Agenda
Hearing Examiner Meeting
Thursday, November 17, 2016
City Hall Council Chamber | 505 Swift Boulevard

S2016-102 - Public Hearing to Review the Preliminary Plat Application of Jolianna Heights, a Residential Subdivision of 55 Lots on 28.4 Acres Located North of Westcliffe Boulevard and South of Shockley Road.

**CITY OF RICHLAND DEVELOPMENT SERVICES DIVISION
STAFF REPORT TO THE HEARING EXAMINER**

PROPOSAL NAME: Jolianna Heights Preliminary Plat

THE PRELIMINARY PLAT OF
JOLIANNA HEIGHTS

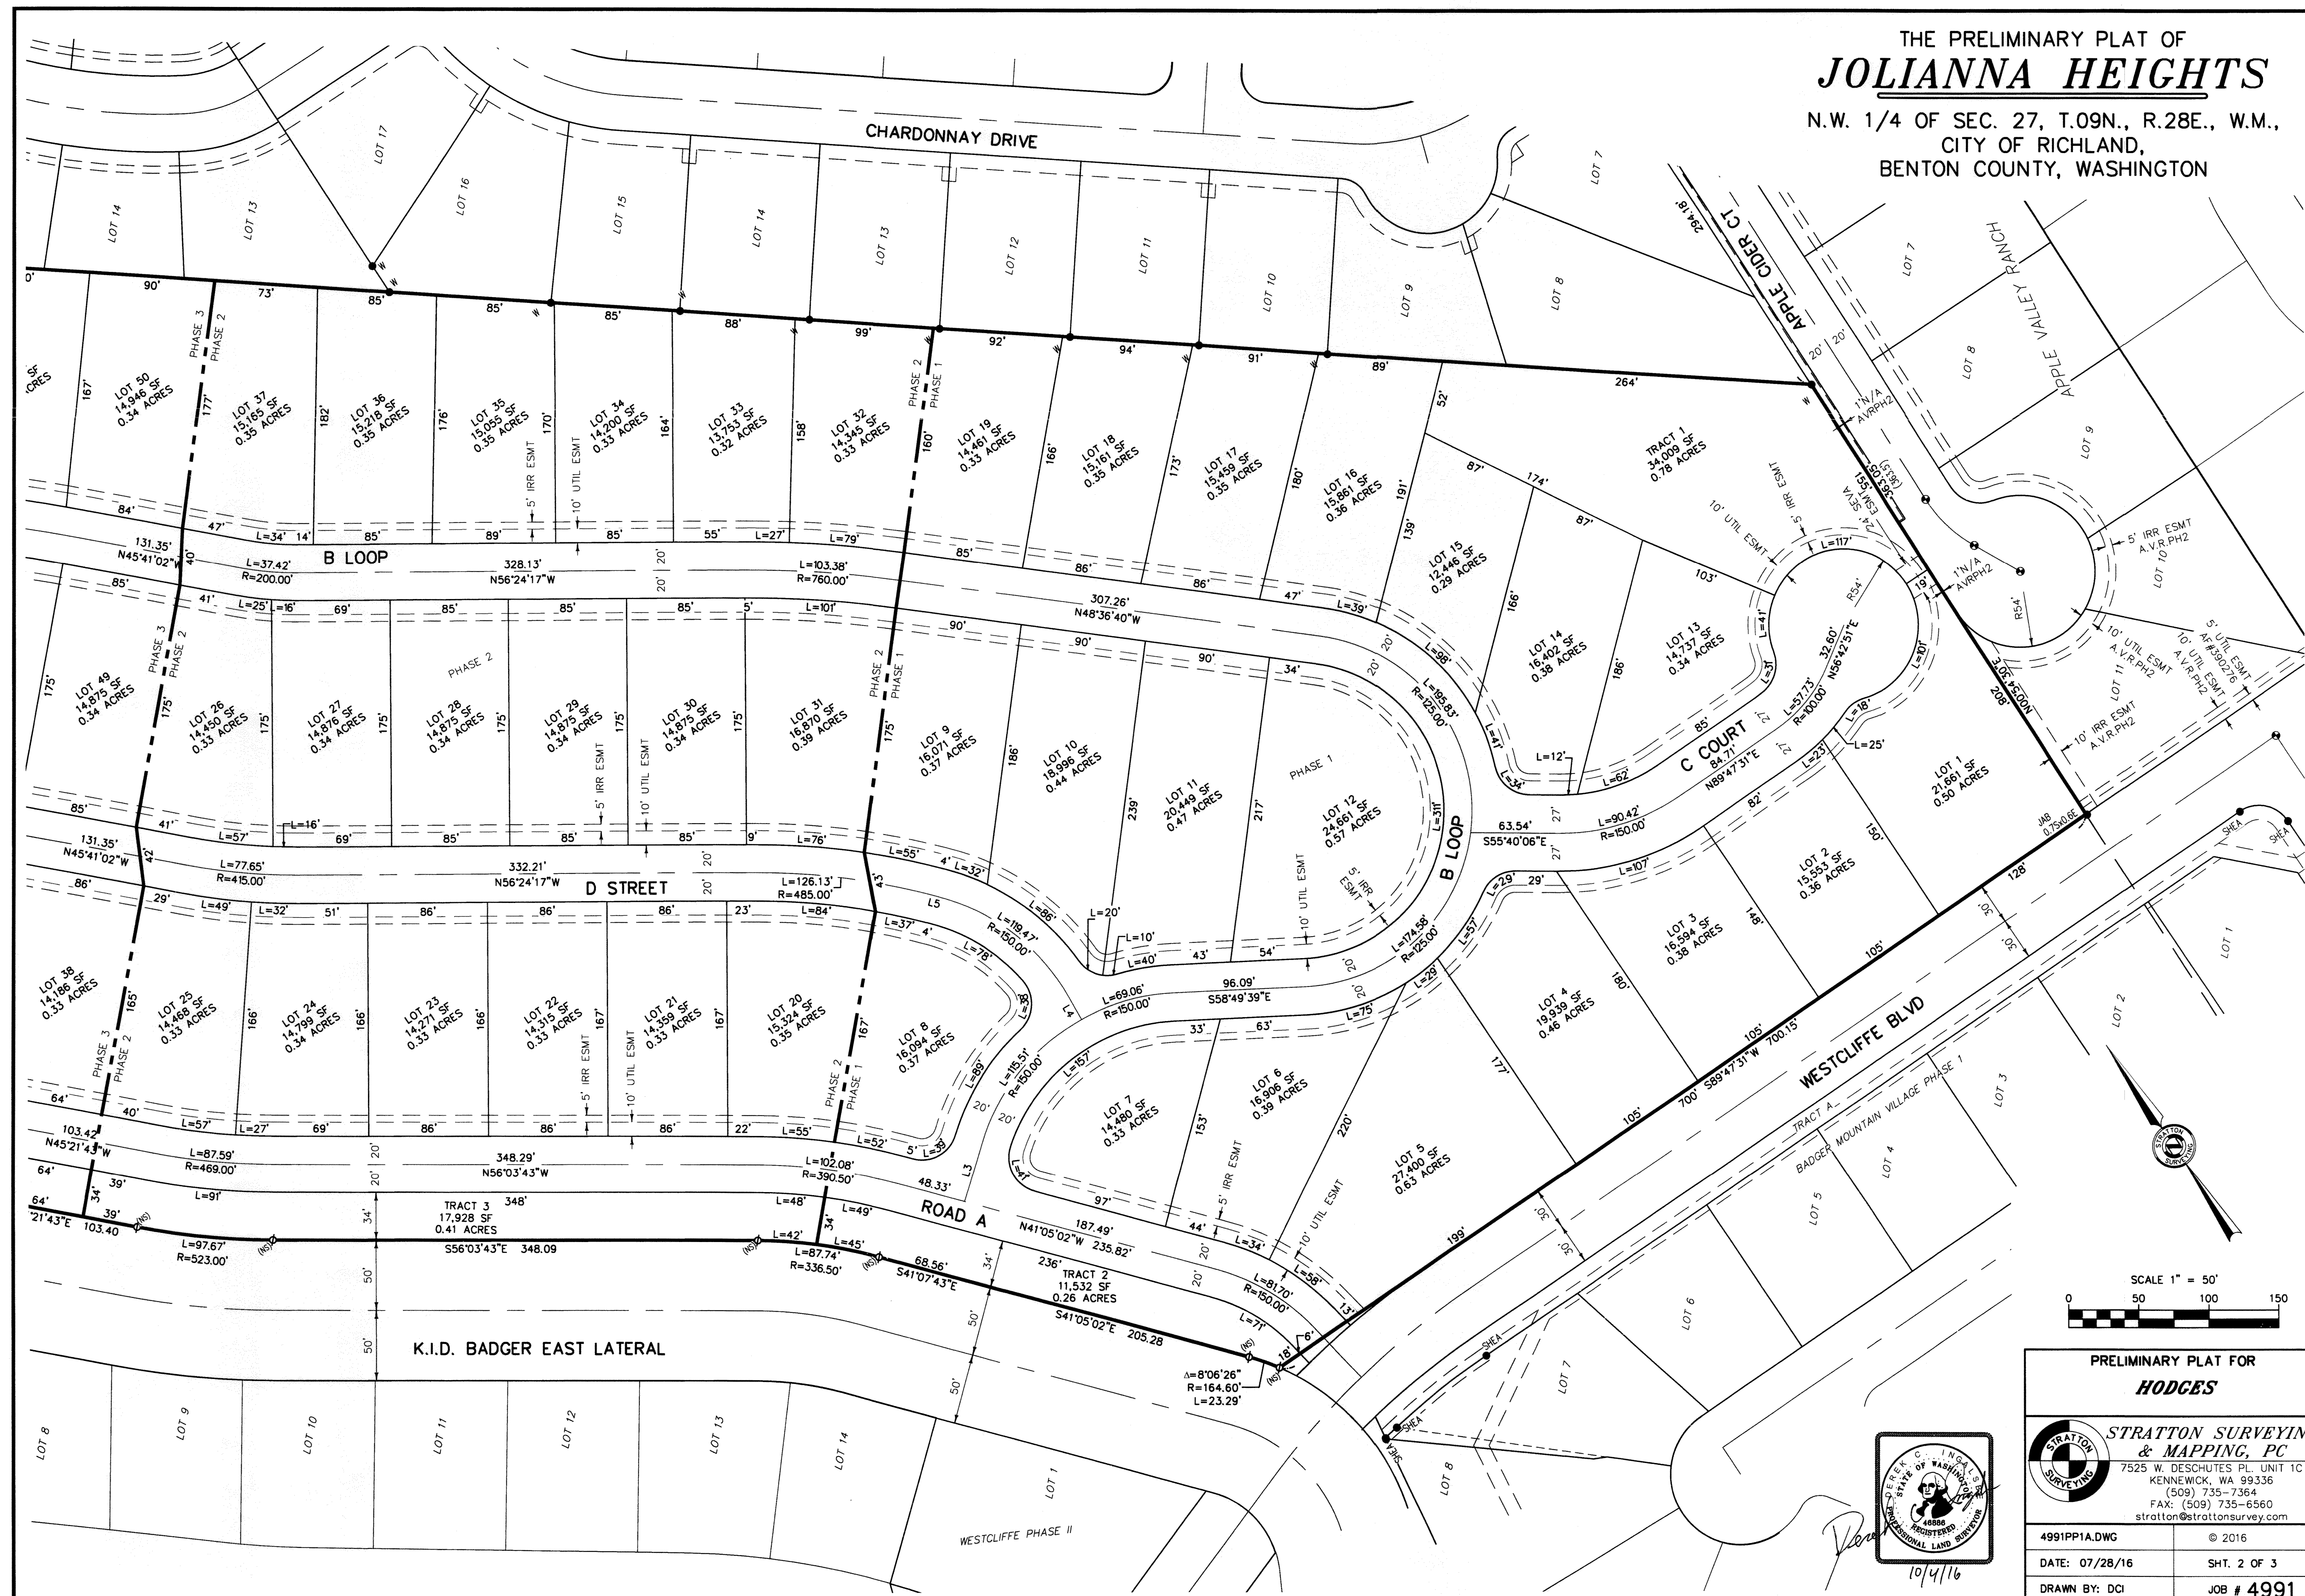
- 2) Please note that there exists a 100 foot United States Bureau of Reclamation (USBR) Right-of-Way (ROW) adjacent to the properties. Please show this ROW on the preliminary plat and indicate if the land under the ROW is owned by the applicant. Copies of the ROW maps are available upon request.

20. There is a 1-foot wide strip of property with a “No Access” easement on it at the S.E.V.A. location shown on sheet 2 (“Tract A” on the plat of Apple Valley Ranch). This project is proposing a secondary emergency access onto Apple Cider Court at that location. Access likely isn’t needed from here as secondary emergency access could be obtained off of Shockley Road. Permission from the property owner of Tract A will have to be obtained prior to constructing the emergency access.

38. There is a 1-foot wide strip of property with a “No Access” easement on it at the S.E.V.A. location shown on sheet 2 (“Tract A” on the plat of Apple Valley Ranch). This project is proposing a secondary emergency access onto Apple Cider Court at that location. Access likely isn’t needed from here as secondary emergency access could be obtained off of Shockley Road. Permission from the property owner of Tract A will have to be obtained prior to constructing the emergency access.
